### THM 440-T4 NEW DESIGN DOUBLE SPRAG ASSEMBLY

**CHANGE:**

Figure 1

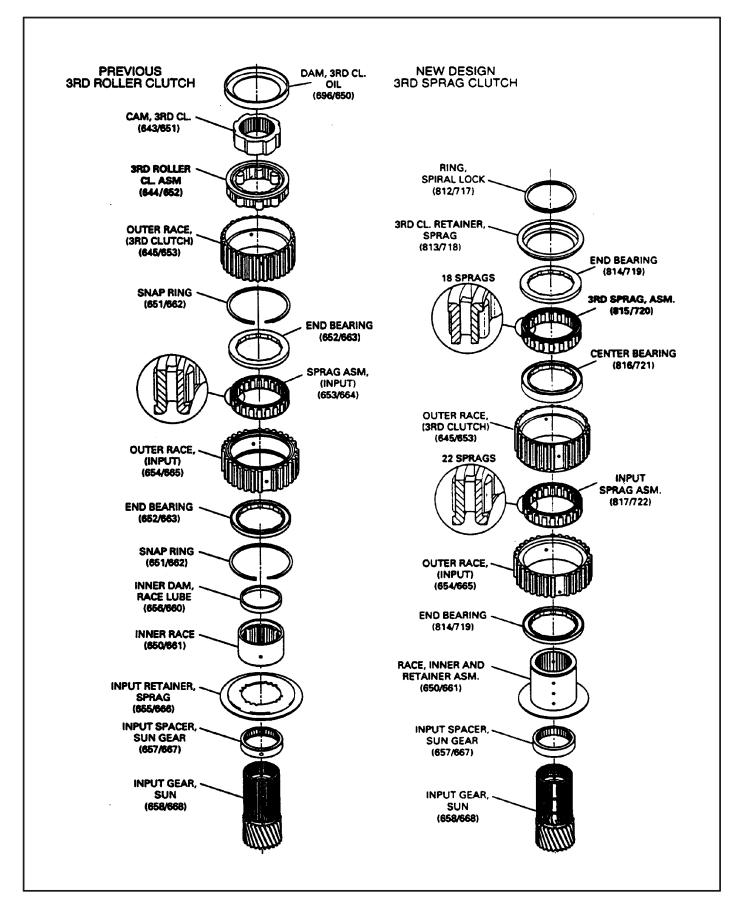
- (1) INPUT/3RD SPRAG ASSEMBLY Completely changed in design and dimensions on all components of the assembly (See Figure 1).
- (2) INPUT SUN GEAR Now has two 'Blind Splines' 180" from one another, to accommodate the new sprag inner race and insure that lube holes are aligned (See Figure 2).
- (3) INPUT SUN GEAR SPACER Revised thickness to accommodate the dimensional changes on the double sprag assembly, and no longer has any lube holes. (See Figure 2).

Figure 2

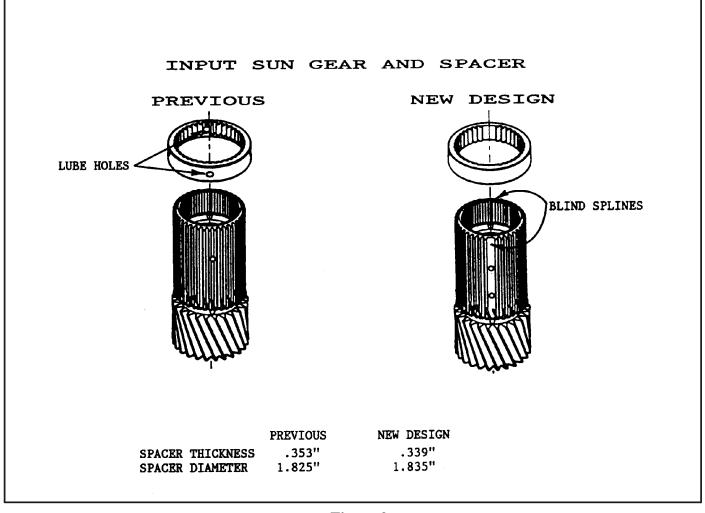
|           | <u>PREVIOUS</u> | NEW DESIGN |
| THICKNESS | .353"           | .339"      |
| DIAMETER  | 1.825"          | 1.835"     |

Figure 3

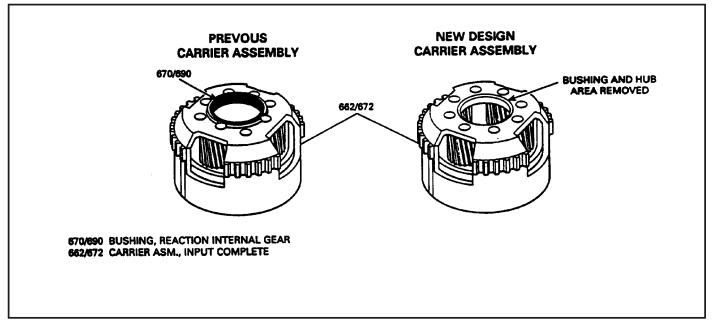
(4) INPUT CARRIER - Lip on top of input carrier completely removed, and the bushing completely removed, to accommodate double sprag assembly. There have also been some internal changes to improve lube and durability. (See Figure 3).

Figure 4

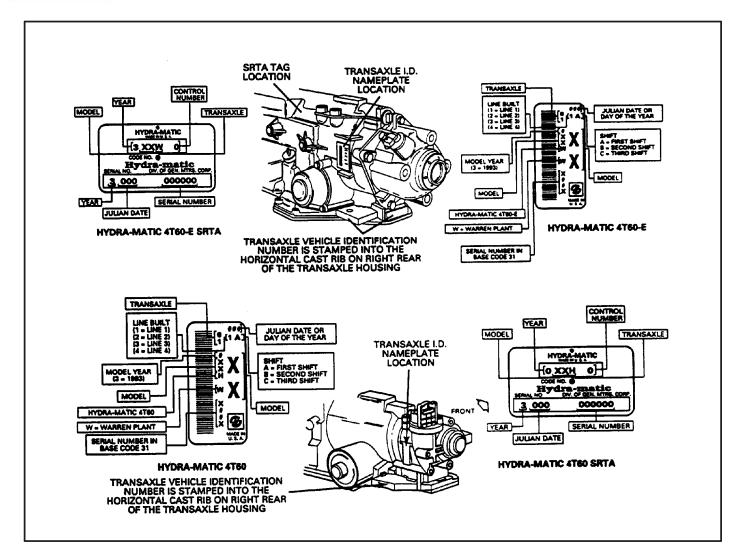
Beginning on February 1, 1993 (Julian Date 032) all THM 4T60-E transaxles were built with a new 'Double Sprag" assembly, in place of the previous 3rd roller clutch and input sprag assembly. Refer to Figure 4 for Julian Date location on the identification tag.
